## **Proposal for amendments to UN Regulation No. 58 (Rear underrun protection)**

The text reproduced below has been prepared by the expert from Germany to introduce amendments in document ECE/TRANS/WP.29/GRSG/2014/18. The entire text of document ECE/TRANS/WP.29/GRSG/2014/18 is reproduced for ease in readability. The modifications to the text in that document are marked in bold and red for new or strikethrough for deleted characters.

“ **Figure 1**

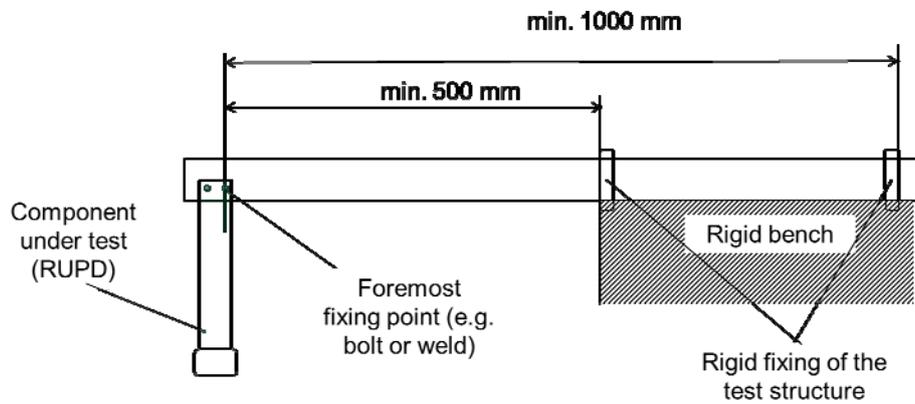
- "1.2. In the case of paragraphs 1.1.2., ~~and 1.1.3~~ the parts ..... of the vehicle chassis ~~or to the rigid test bench~~ shall be ..... on the vehicle. **The part of the chassis can be fixed on a rigid test bench as shown in Figure 1, representing the minimum requirements to be fulfilled. The structures used as side rails shall be representative of the chassis of vehicles for which the underrun protection system is intended.**"

Annex 5, insert a new figure after paragraph 1.2.:
